**HISTORIC PRESERVATION REVIEW BOARD
STAFF REPORT AND RECOMMENDATION**

Landmark/District: **Walter Reed Army Medical Center Historic District** (x) Agenda
Address: **6800¹ Georgia Avenue NW**

Meeting Date: **May 4, 2017** (x) New construction
Case Number: **17-304** (x) Alterations

The applicant, TPWR Developer LLC, a joint venture of Hines-Urban Atlantic-Triden and the lessee of the District-owned portion of the Walter Reed campus, requests conceptual review of a proposal to construct an apartment-condominium-retail complex at the south corner of the campus, adjacent to contributing buildings 8 and 9 (General Officers Quarters) and 90 (fire station).

A detail of the 2015 master plan.

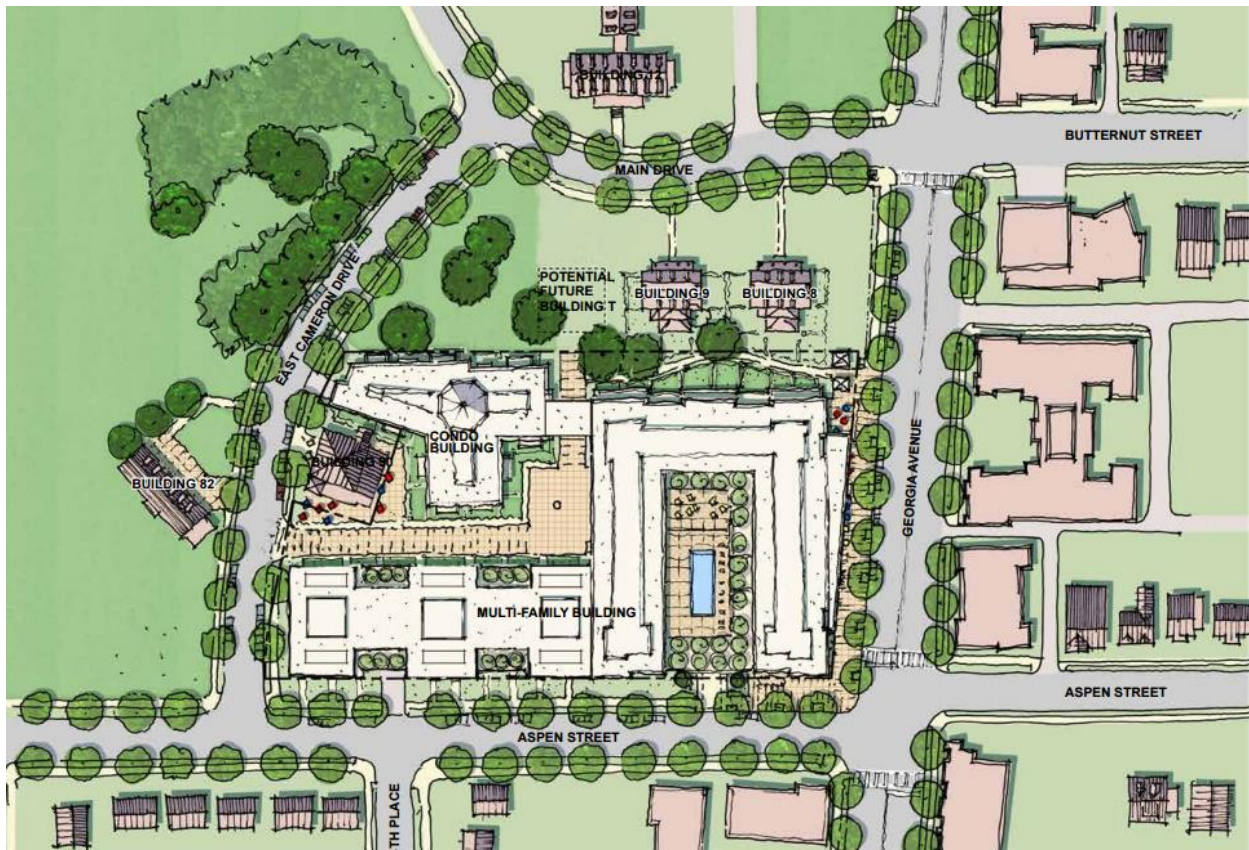
Building U/V, southeast corner of the campus (see pages 46-49): Another five-story building, this site would most benefit from having a specific program attached to it, so that the reality of the project, and especially the building's footprint, could be properly evaluated. It is quite close behind the General Officers' Quarters, Buildings 9 and 10. The simulation makes it appear that there is an attempt to step down toward those buildings (see page 47), but the inset site plan seems to put that mass almost immediately behind Building 8. The good thing about the footprint of the building is that it is broken up into north-south pavilions that would face Buildings 8 and 9 end on. Yet, the whole is sprawling and not only close to those historic buildings, but wraps around the contributing fire station, Building 90. Some credit should be given, however, to forgoing an additional building in the heavily treed area west of Building 9...

The Board's action generally supported the heights proposed for new buildings, with the caveat that more information on massing, views, the treatment of spaces between and the landscape in general is necessary to be definitive on each. The Board expressed some concern about possible crowding of Buildings 8 and 9 by the buildings in this area.
